North Country Environmental Services, Inc.

February 20, 2009

**Re: North Country Environmental Services, Inc.
Landfill Facility – Bethlehem, New Hampshire
Groundwater Performance Standards**

Total VOCs in Well MW-402U

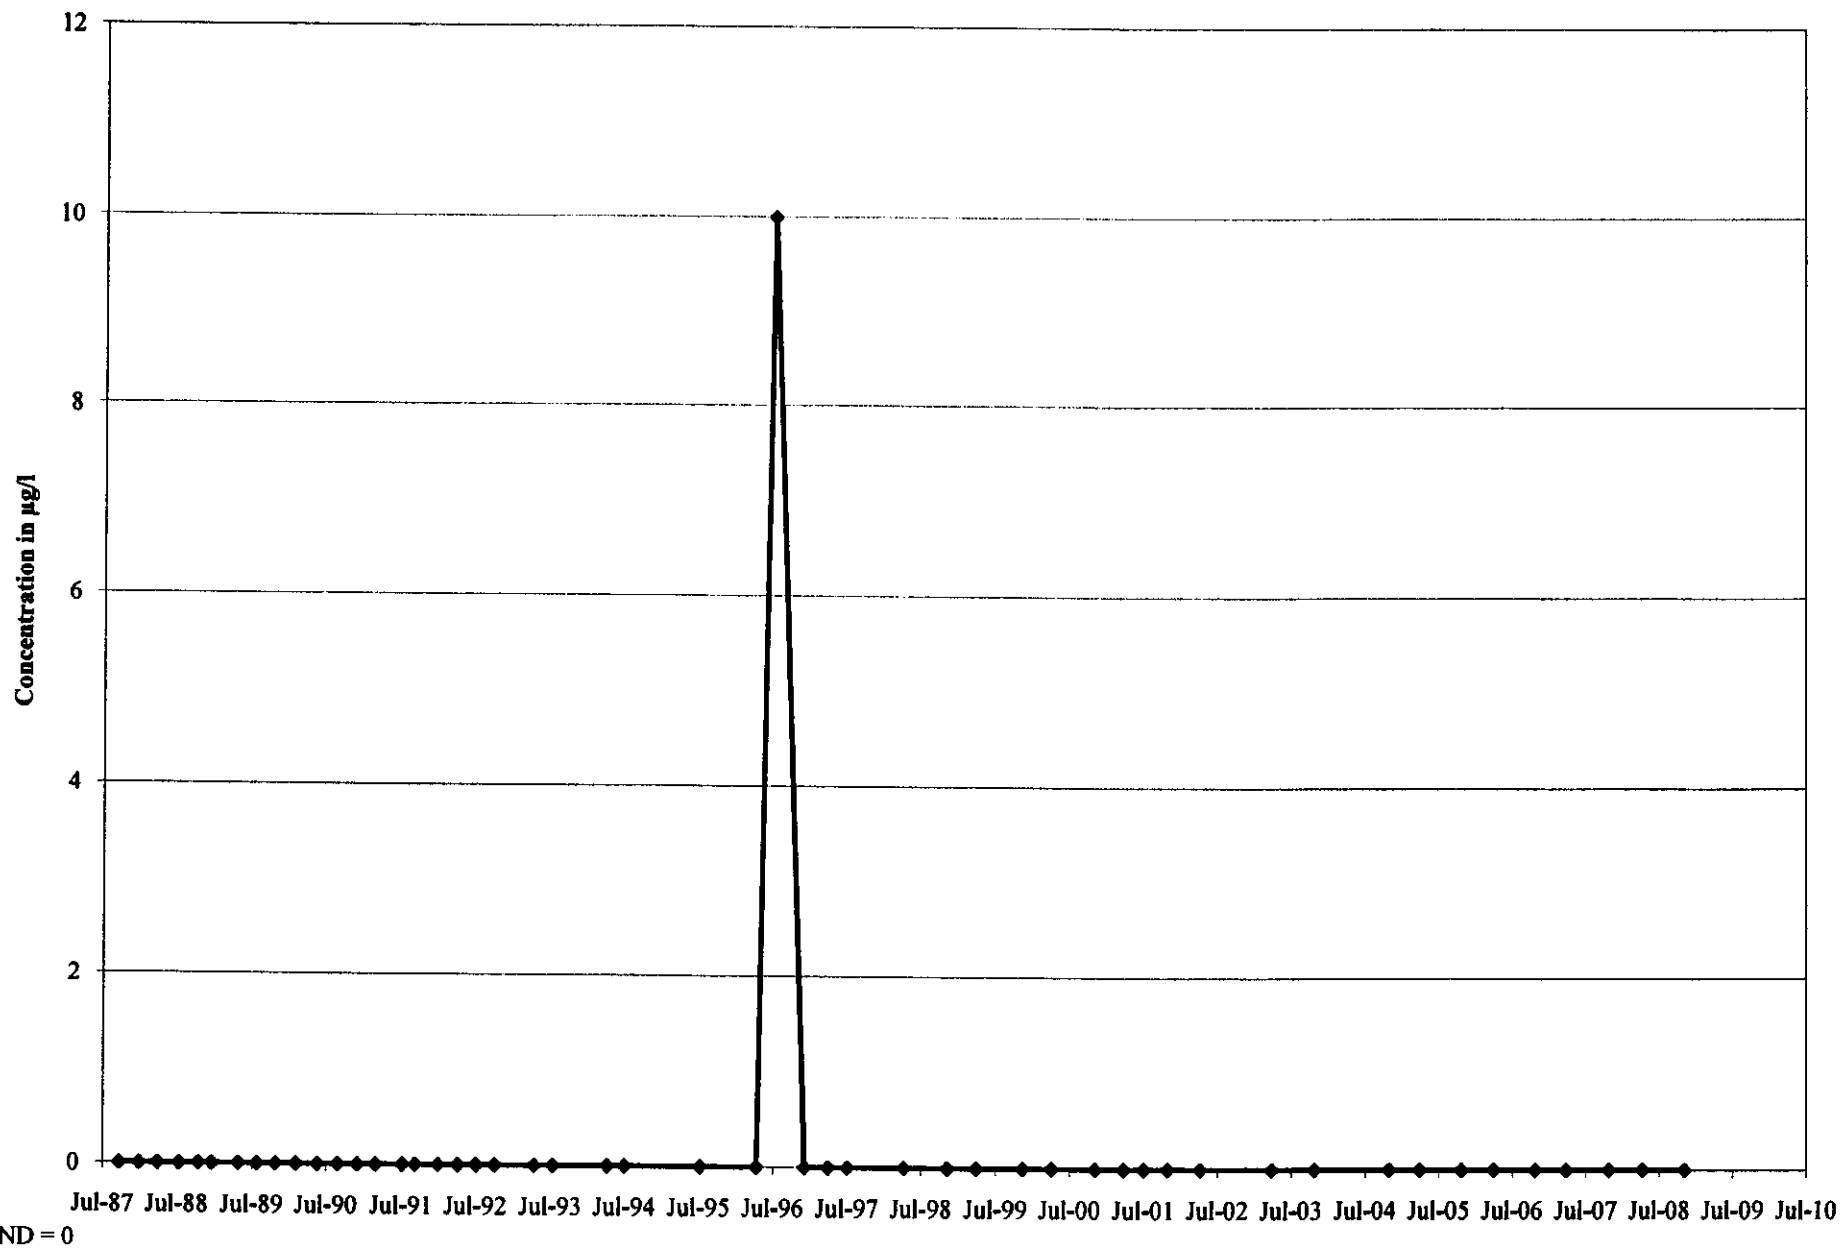
The Department agrees in concept with monthly monitoring until sampling confirms that a downward temporal trend is established. However, due to the variability of the water quality data, more than two consecutive rounds will be required to determine that there is a downward trend in VOCs and bromide concentrations. As indicated above, groundwater quality must be restored to background concentrations. During implementation of the corrective action plan, the Department may be able to conclude that the source has been identified and effectively remediated, but continued groundwater monitoring under the Corrective Action Plan would still be required until groundwater quality is restored to background concentrations for VOCs and bromide. Depending upon the information collected during the remediation of the area in the vicinity of the leachate collection system and whether a source area (e.g. contaminated soil) is discovered and

The Department does not concur that 0.4 mg/L of bromide is the appropriate target concentration to demonstrate that background has been achieved. NCES will need to look at individual well histories to see what the actual background concentrations were in the affected wells. In previous discussions between NCES and the Department, we agreed that background bromide concentrations at the site ranged between 0.1 and 0.4 mg/L, not that 0.4 mg/L should be identified as the background concentration to be applied to all wells. Future monitoring results will be reviewed closely to assess trends.

The source of the VOCs and bromide detected in the 402/403 series wells is from prior leachate handling practices at the site. The maximum concentration for total VOCs at any of these wells was 87 mg/l in 2004 and we have since experienced an overall downward trend in total VOC concentrations (please refer to the attached graphs) that demonstrates the cause has attenuated and is not from a chronic source. Recent sampling confirms that in three of the four 402/403 series wells there is no detection of VOC's, further supporting our conclusions.

With respect to background concentrations and based upon historical data, we propose the following;

| Location | proposed total VOC (mg/l) | Proposed bromide concentration (mg/l) |
|------------|---------------------------|---------------------------------------|
| MW-402L/LR | ≤10.0 | Non-detect (< 0.1) |
| MW-402U | ≤10.0 | ≤ 0.1 |

Subject to our prefatory remarks we propose to continue to collect groundwater samples from wells MW-402U and MW-403L for VOCs and bromide analysis monthly until such time as the above background levels are obtained.
